**RECALL CAMPAIGN  
INSTRUCTIONS**

**REF. NO. C24100080**

**REPLACEMENT OF BRAKE FLUID  
RESERVOIR CAP**

Ferrari \_\_\_\_\_  
**F8TRIBUTO**

Page Location to Apply  
New Adhesive Sticker

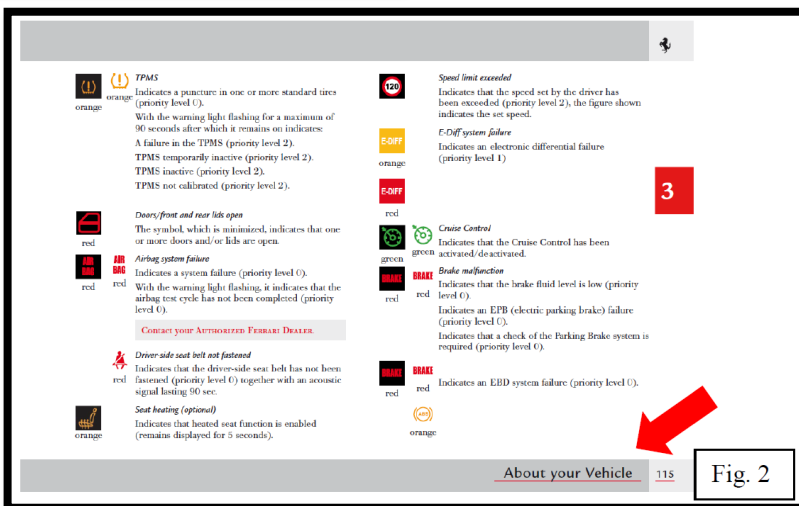
Please find below the proper location and instructions on how to insert the provided sticker into the Owner's Manual (PN: 079641778)

The sticker must be placed on the page shown above in the Owner's Manual. This page is located in the **"About Your Vehicle"** section where the warning lights on the instrument panel are described. Please be sure to attach it to the page with the **"Low Brake Fluid"** description as shown above in Fig. 2.

Once you locate the proper page, remove the adhesive protector off of the back of the sticker. Ensure there is no residue or other particles on the page that may inhibit the longevity of adhesion to the page. Place the sticker to allow the bottom of the sticker to lay directly above the gray margin at the bottom of the page that contains the text **"About your Vehicle"**.
